802.3dj D2.0

Comment Resolution

Electrical Track

Figure 178-2—200GBASE-KR1, 400GBASE-KR2, 800GBASE-KR4, or 1.6TBASE-KR8 link

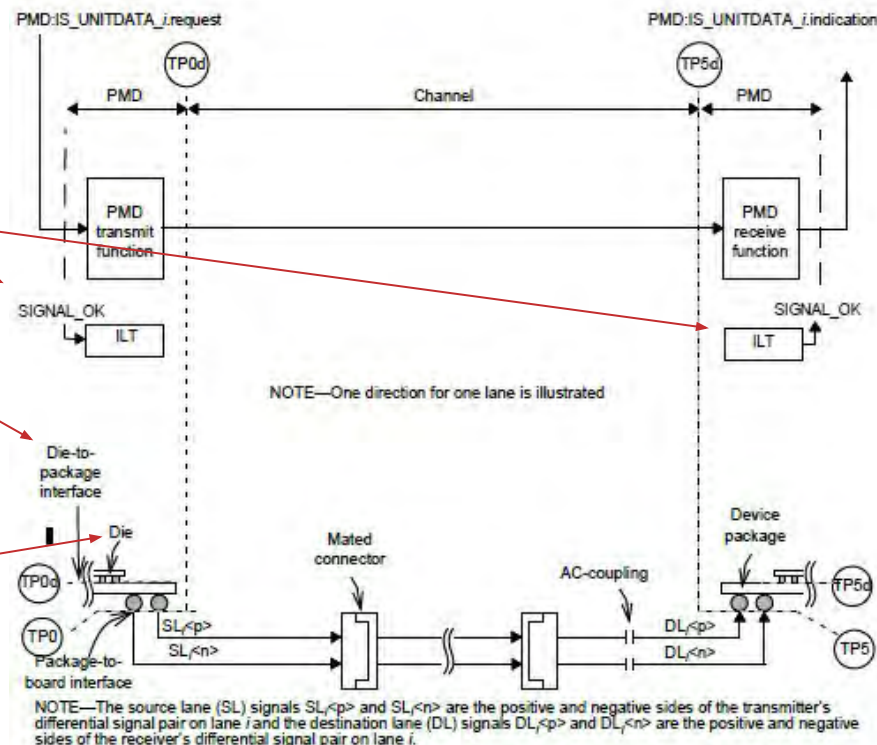
In Figure 178-2 add the ILT function above the PMD transmit and receive functions. Show the SIGNAL_OK as an input to the ILT function at the left side and as an output to the ILT function in the right side (refer for example to Figure 180-2)

The test points in the figure are not the test points at which the OMD is specified. The PMD is specified at TP0v, which is not shown in the figure. The first sentence starting with "The test points" implies that these are the only test points.

Figure 178-2. The interface at TP0 is helpfully labelled as "package-to-board interface". A similar label would be helpful at TP0d.

In Figure 178-2, make the following changes:

Show the PMD ending and "channel" beginning at TP0 and TP5.

Add a label at TP0 and TP5 "MDI".

Change label pointing to the die on the left side of the Figure 178-2 to "Die".

- 92: Add the ILT function & SIGNAL_OK above PMD function.

- 302: Label “Die-to-package interface at TP0d. Also apply to Figure 176C-2.

- 303: Show channel going from TP0 to TP5. Add “MDI” at TP0 & TP5. (and in Figure 176C-2)

- 304: Change label on die at left from 'device' to 'die'.

- 640: Change subclause title. Add sentence to 1st paragraph stating that the PMD is specified at TP0v & TP5v.

176D.8.2 Effective return loss (ERL)

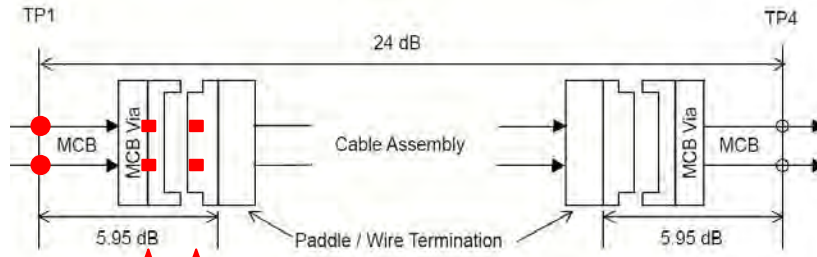
CI 176D	SC 176D.8.2	P 752	L 29	# 361
Ghiassi, Ali Ghiasi Qunatum/Marvell				
Comment Type	TR	Comment Status	D	(Electrical) Tfx
Line 30 says that "Tfx equal to twice the test fixture delay", statement is not clear.				
Suggested Remedy				
Tfx for measurement of Host Input/Output is twice the HCB delay. Tfx for measurement of Module Input/Output is twice the MCB delay. Suggest to move Tfx into the table and make the above as footnotes in the table. We shouldn't state in IEEE standard "Tfx is provided by the test fixture provider", what about if fixture supplier doesn't?				
Proposed Response Response Status W				
PROPOSED REJECT. The test fixture delay is defined in detail in the second paragraph of 176D.8.2 for both host and module measurements. Based on these definitions, the statement should be clear. The suggested remedy does not match the second paragraph and would not improve clarity. The statement that "Tfx is provided by the test fixture provider" was added by the response to comment #199 against D1.1, see < https://www.ieee802.org/3/dj/comments/D1p1/8023dj_D1p1_comments_final_clause.pdf#page=77 >. It should be understood as a requirement. The suggested remedy does not provide an alternative phrasing for this statement.

This comment is specifically about the span of Tfx in a cable assembly test fixture (aka MCB).

This comment seems to address both MCB and HCB.

Figure 176D-5—Module compliance points

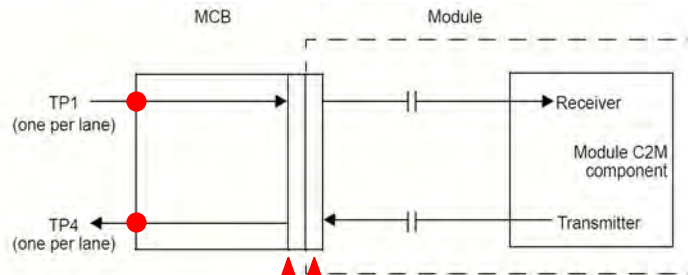
- A: MCB connector pads
- B: Receptacle mating point (Cable/HCB pads/Gold Fingers)
- C: Somewhere else?

(Top of Figure 179A-1)

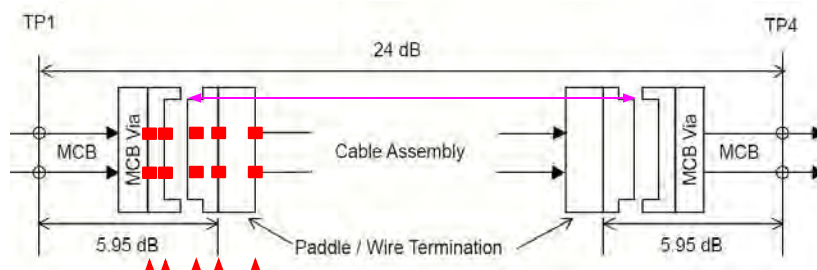
- Is the text “Paddle / Wire Termination” in the Figure clear, and useful?

CI 179A	SC 179A.5	P 821	L 4	# 658
Swenson, Norman		Nokia, Point2		
Comment Type	TR	Comment Status	D	(Electrical) CR test fixture
What is the extra rectangle labeled Paddle/Wire Termination shown in Fig. 179A-2 that is not shown in the mated test fixtures in Fig 179A-1? It is not explained in the text.				
Suggested Remedy				
Clarify				
Proposed Response		Response Status W		
PROPOSED ACCEPT IN PRINCIPLE.				
The rectangle and labels "Paddle/Wire Termination" serve as demarcation of the cable assembly and the host channel, in Figures 179A-1, 2, and 3. The "Paddle" and "Wire Termination" are structures associated with the cable assembly, and are not necessarily present in an HCB (or Mated Test Fixture). The labels are used to identify specific structures that are not documented elsewhere in the figure.				
These figures provide illustration as appropriate within an informative Annex. Similar figures with the same features are included in in Annex 162A, added by IEEE Std 802.3ck.

The suggested remedy does not contain sufficient detail for the CRG to discuss a specific change.

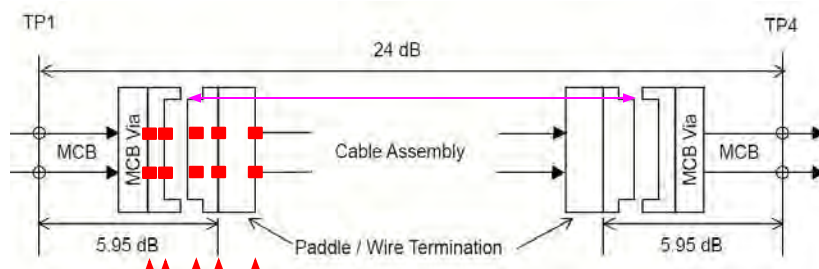
MCB connector pads
MDI receptacle interface
Receptacle mating point
(Cable / HCB pads / Gold Fingers)
Ambiguous Test Point
Paddlecard / DAC wire termination

CI 179A	SC 179A.5	P 820	L 39	# 289
Heck, Howard		TE Connectivity		
Comment Type	TR	Comment Status	D	(Electrical) CR test fixture
<p>MCB loss specified in the lower left of Figure 179A-1 is not directly measurable as it is currently specified. Indirect measurement methods do not provide the necessary accuracy. The version of the figure in D1.4 was measurable and reverting back to it will resolve the problem. Equation 179B-2 requires modification to make it accurately represent the MCB insertion loss measured with the 2Xthru method</p>

CI 179B	SC 179B.2.1	P 823	L 34	# 513
Dudek, Mike		Marvell		
Comment Type	TR	Comment Status	D	(Electrical) CR test fixture
The loss needs to be better defined to be less ambiguous.				
Suggested Remedy				
Insert the sentence "The cable assembly tested fixture loss is equal to the loss of the mated test fixture minus the loss of the specific TP2 or TP3 test fixture printed circuit board loss used when measuring the mated text fixture loss." between the 1st and 2nd sentences.				
Proposed Response		Response Status	W	
PROPOSED ACCEPT IN PRINCIPLE.				
The suggested remedy addresses the ambiguity in the definition of ILcatf, but introduces an additional ambiguity regarding the definition of ILtfref. As a result, the specification is not necessarily less ambiguous.				
Discuss with comment #289.				
[Editor's note: Changed Page from 823 to 824]
